SUBJECT: Accept the Low Bid and Award the Contract for the Construction of Grand Avenue Resurfacing and Widening Project, Community of Lakeland Village. 1st District; [\$4,523,019]; Local Funds 100%

Project Number: C4-0074

MODIFICATIONS / CLARIFICATIONS TO PLANS

DESIGNED BY APPROVED BY:  <i>Michael O. Mueeting</i> DATE: 1-29-15	CONSTRUCTION DETAILS GRAND AVE RESURFACING & WIDENING STA 150+00 TO 155+00	SHEET No. C-1 SHEET 13 OF 24
--	---	--

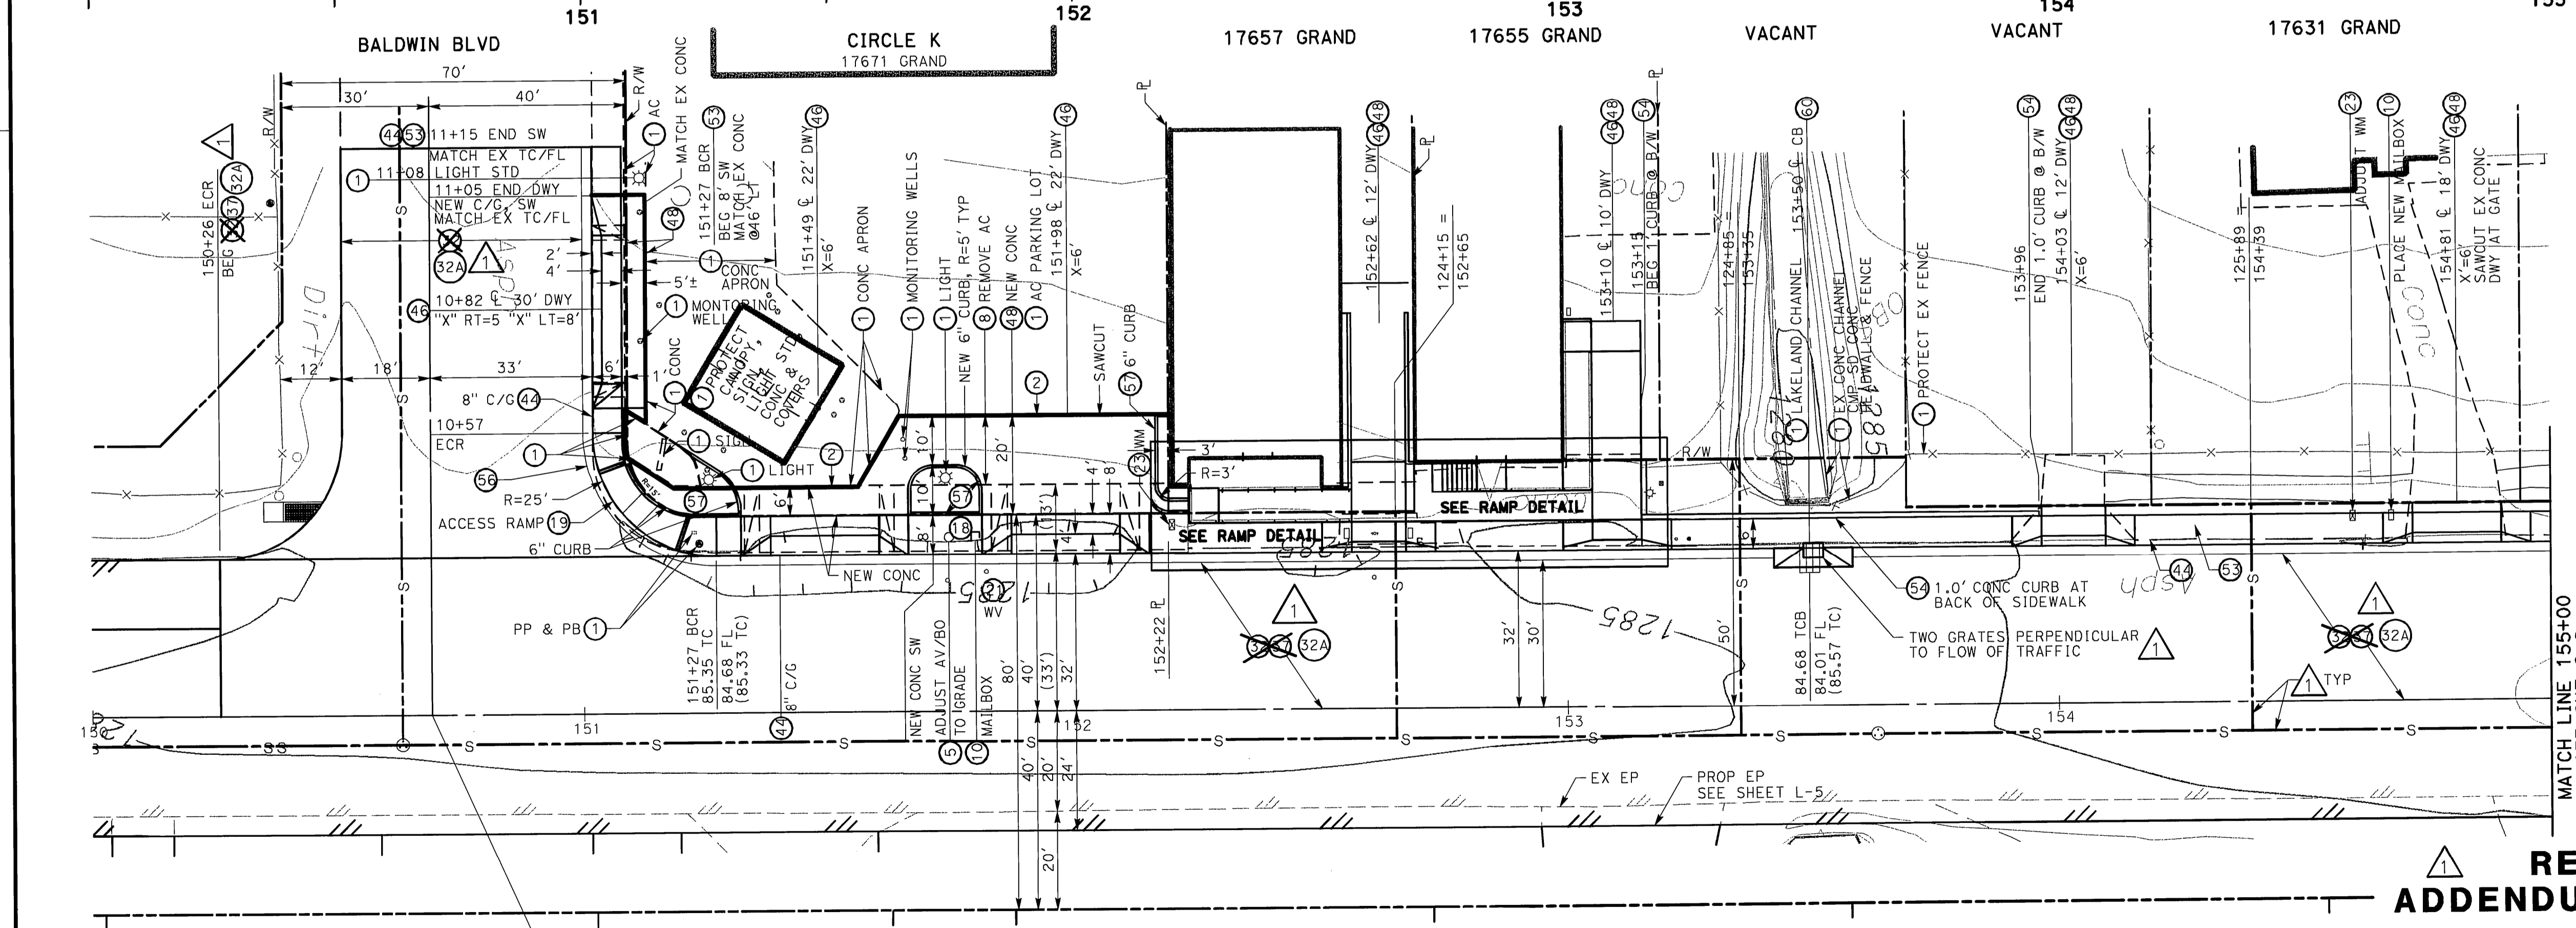
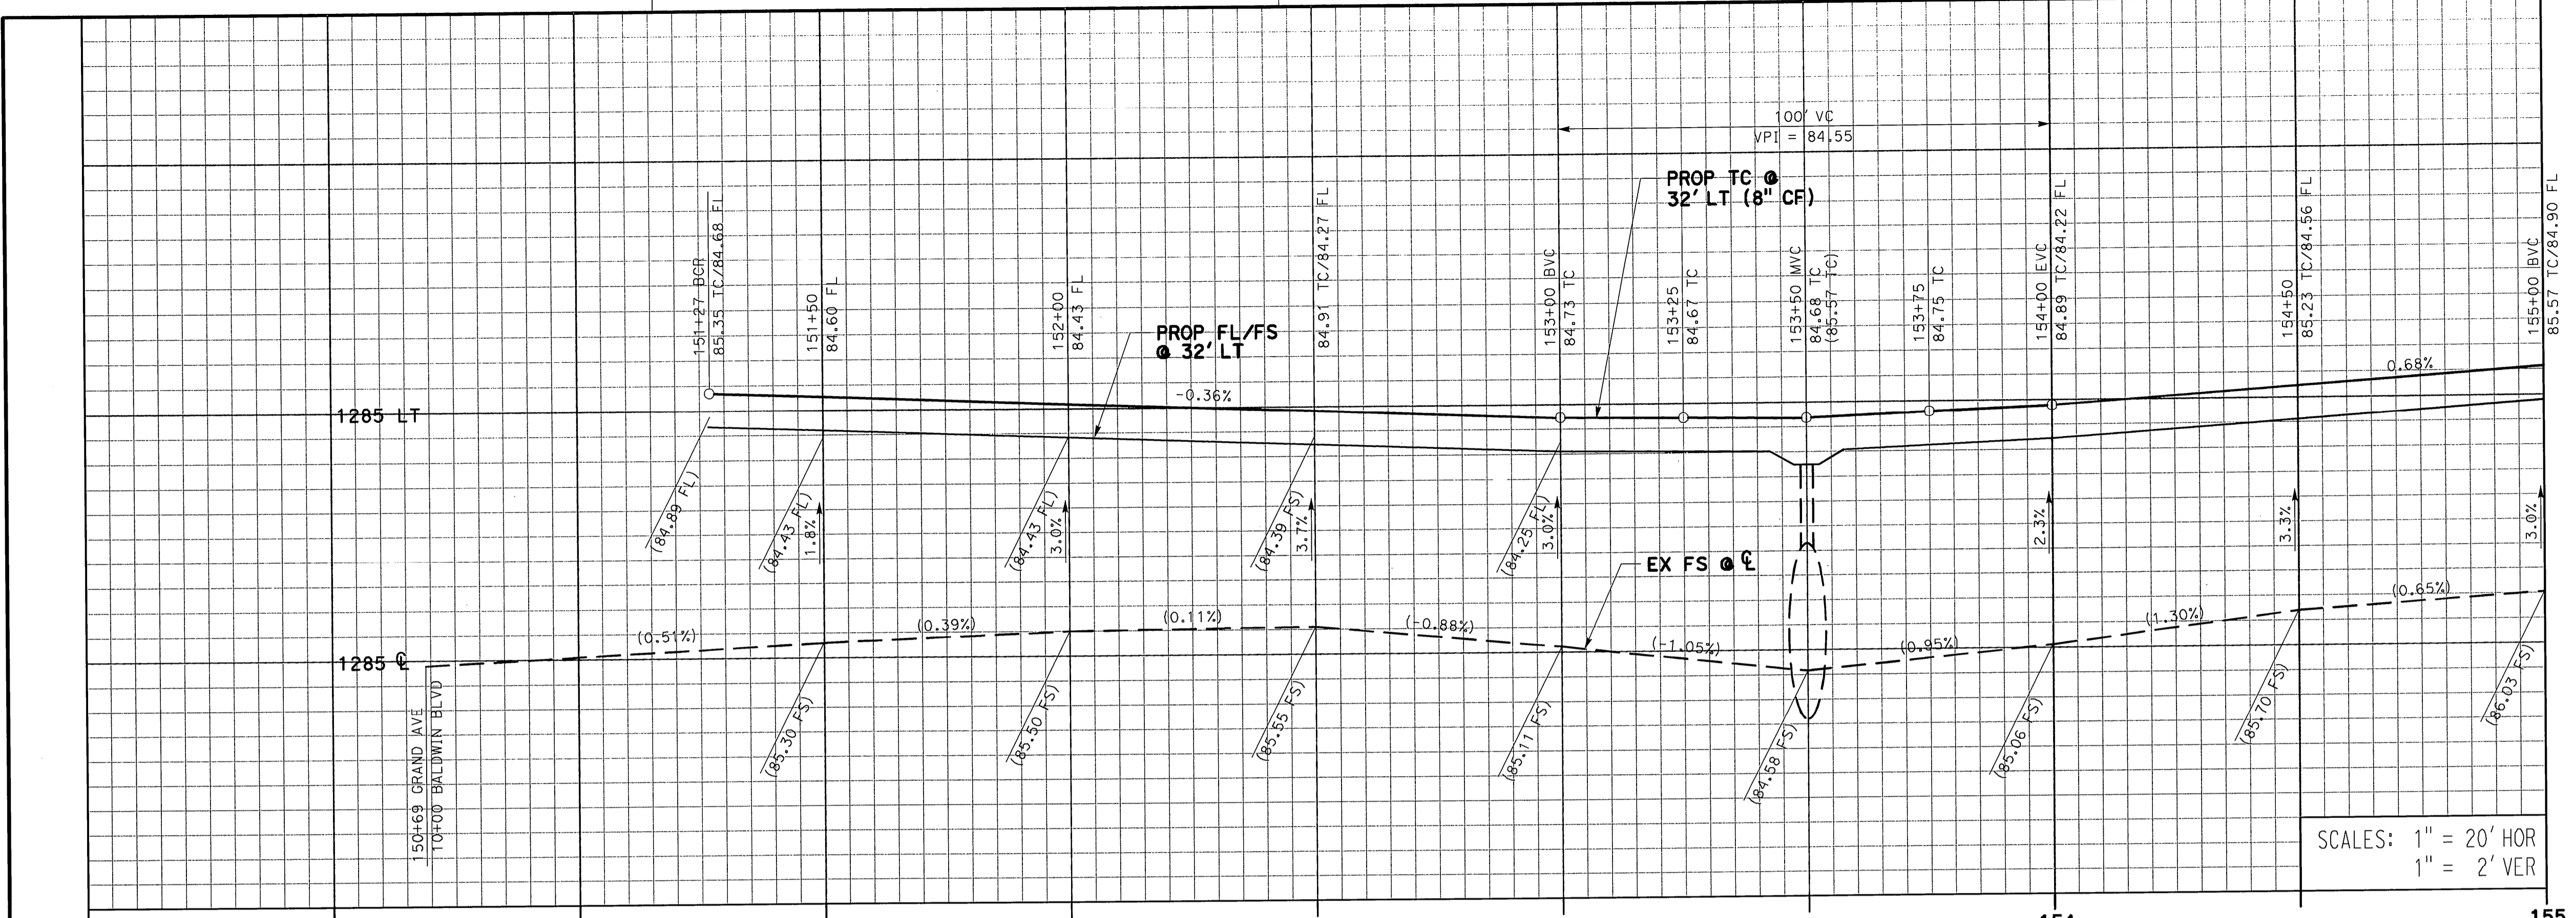
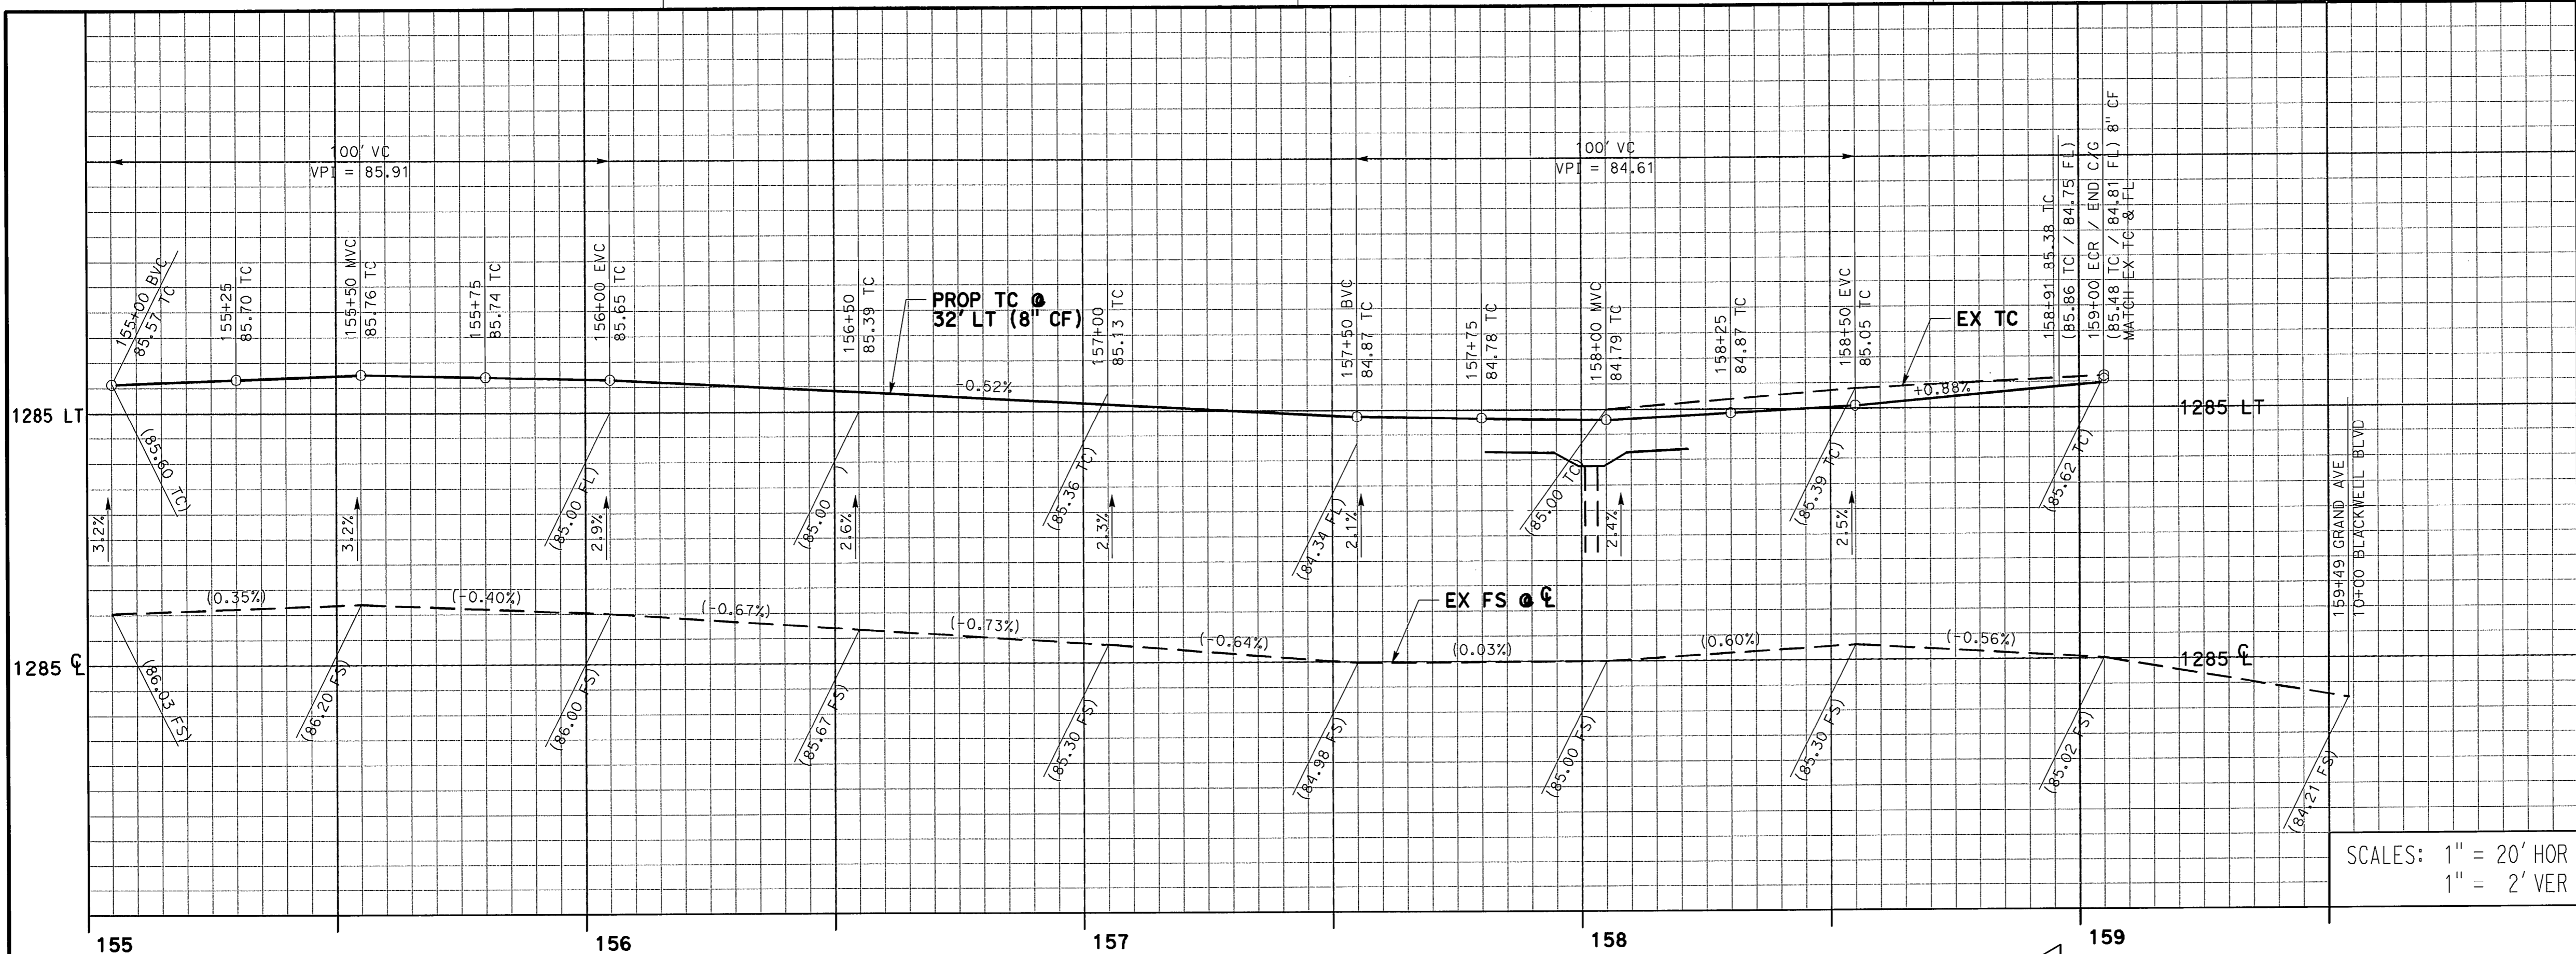
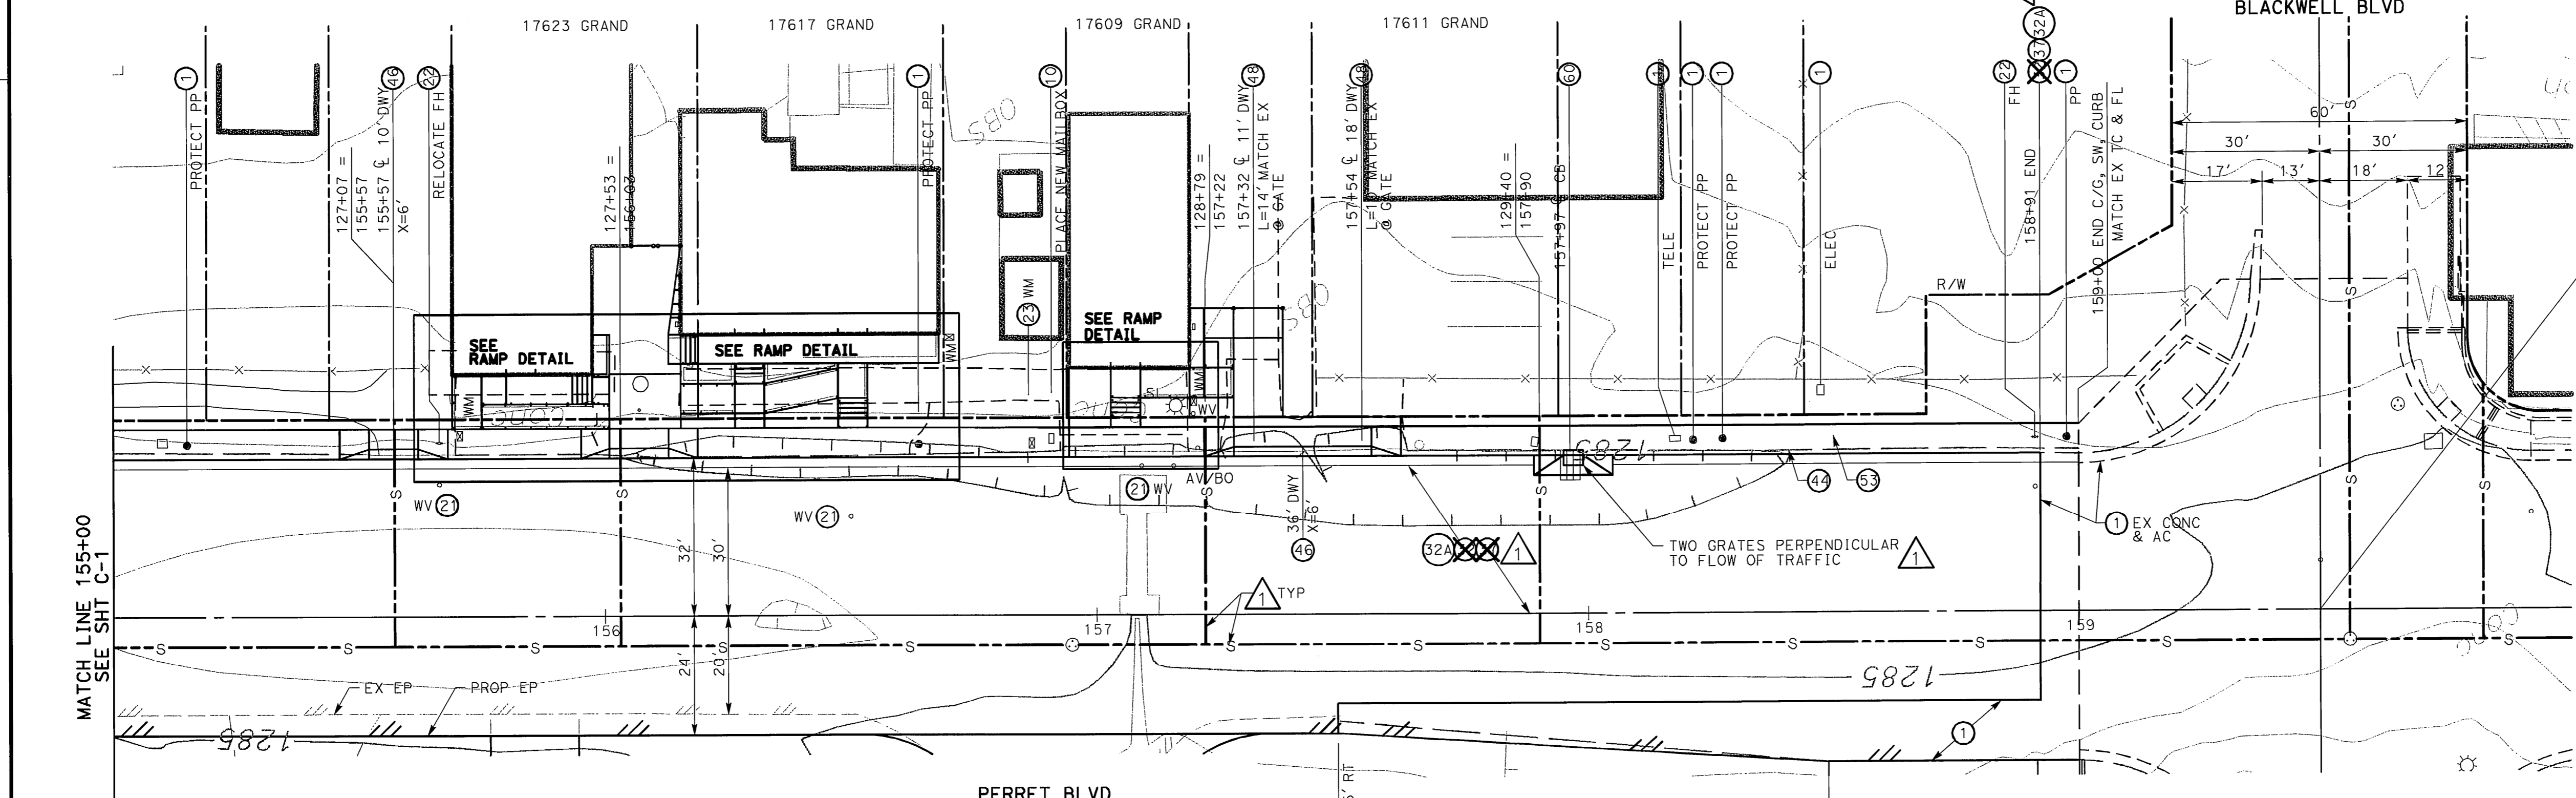
2. **Plan sheet C-1 (13 of 24)**

- Approximate Location of sewer laterals and underground utilities are added
- Construction Note 60 is revised to include "Two Grates-Perpendicular to the flow of Traffic"
- Construction Note 32 is deleted and 32A is added
- Construction Note 37 is deleted
